Proposal: Outline application for 5No. detached chalet style dwellings, 1No. detached bungalow, and one pair of semi-detached two storey dwellings with ancillary garaging and car parking spaces, creation of new vehicular crossover and closure

Site: 11 Bound Lane, Hayling Island, PO11 9HU.

APP/15/01074

Southern Water MapGuide Browser

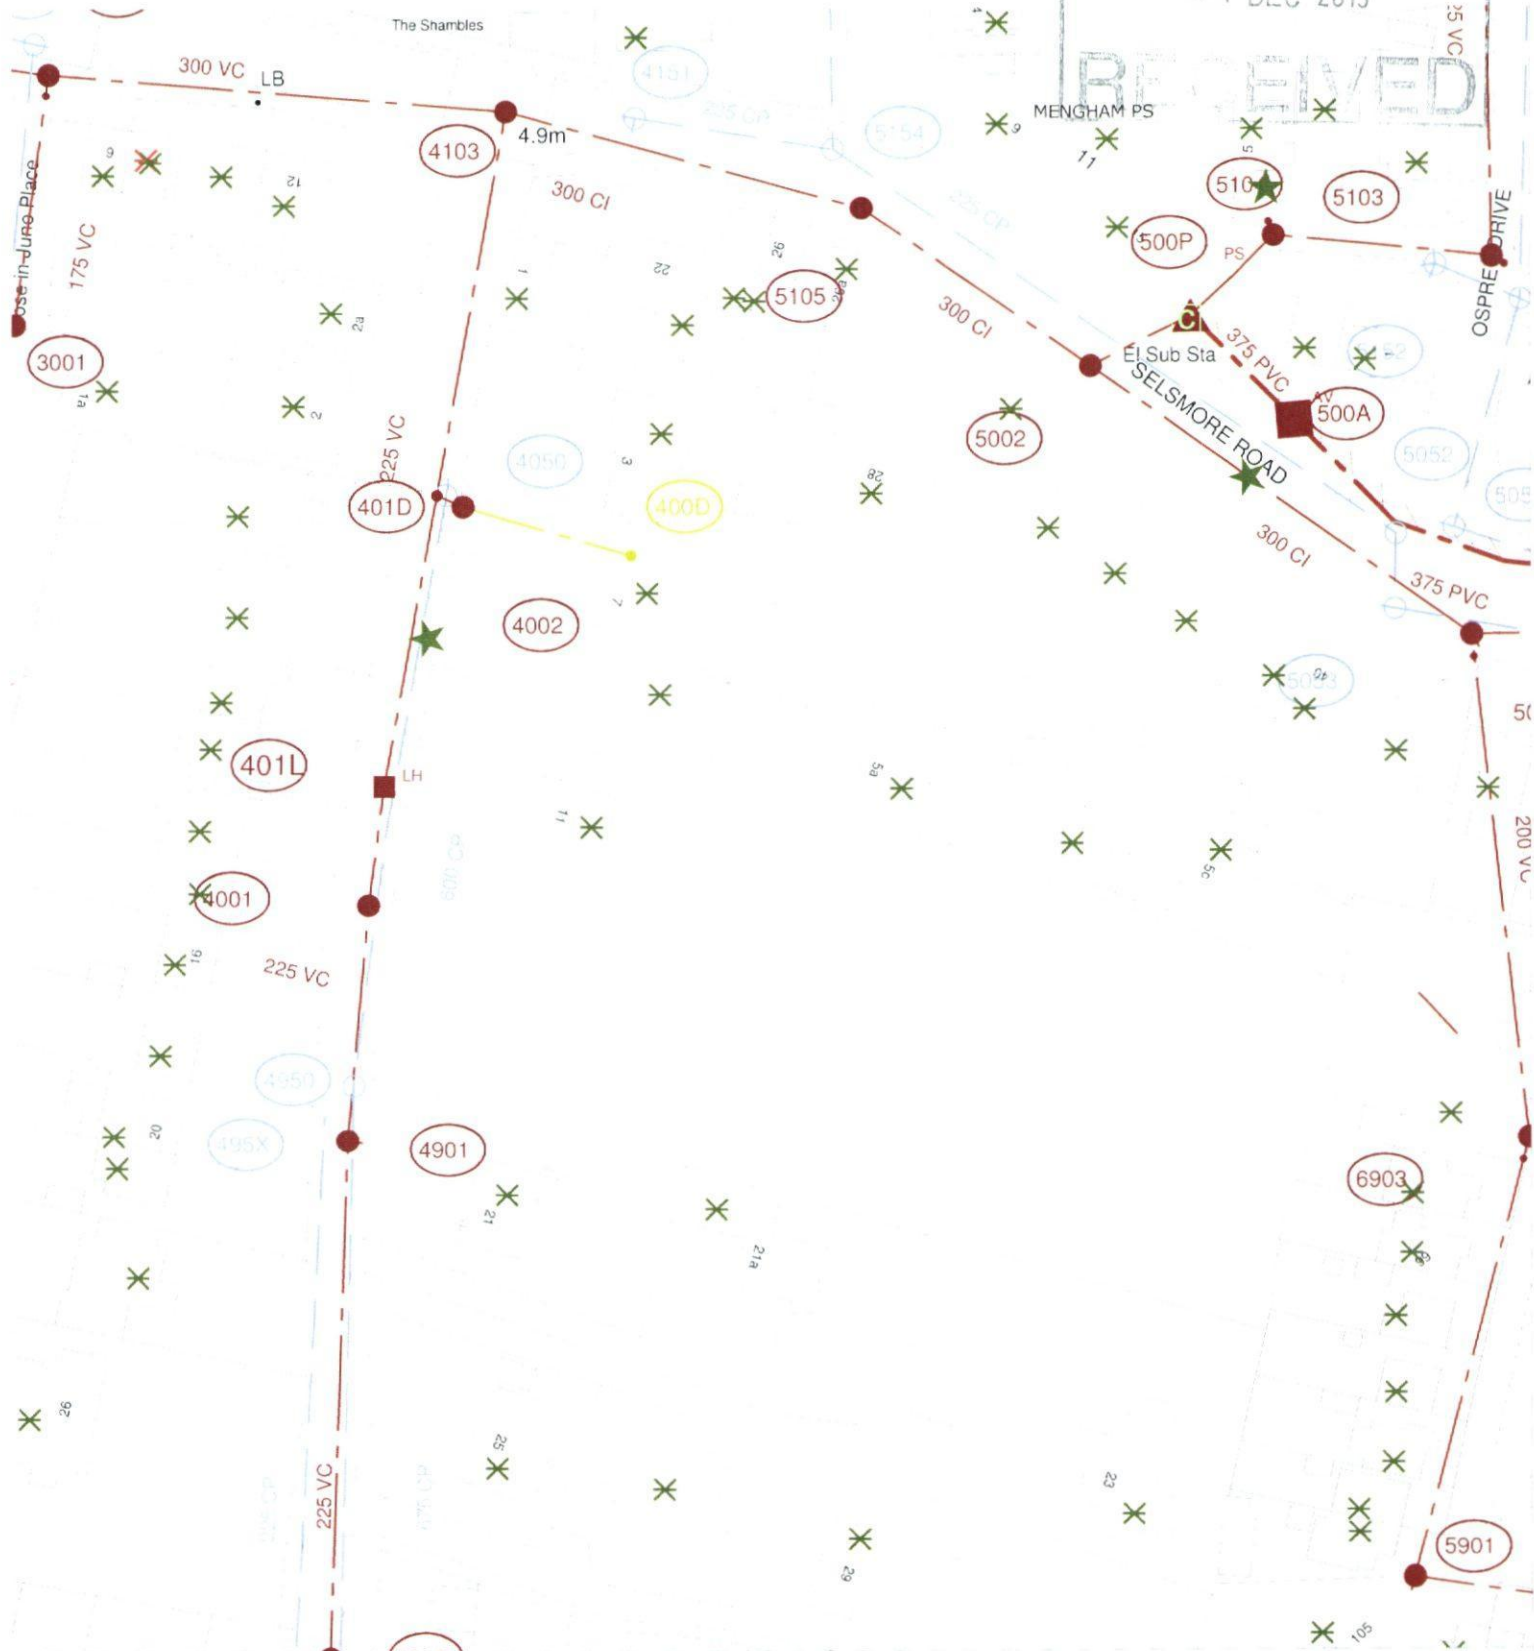
Please note no new soakaways should be located within 5 metres of a public (or adoptable) sewer.

Due to changes in legislation that came in to force on 1st October 2011 regarding the future ownership of sewers it is possible that a sewer now deemed to be public could be crossing the above property. Therefore, should any sewer be found during construction works, an investigation of the sewer will be required to ascertain its condition, the number of properties served, and potential means of access before any further works commence on site.
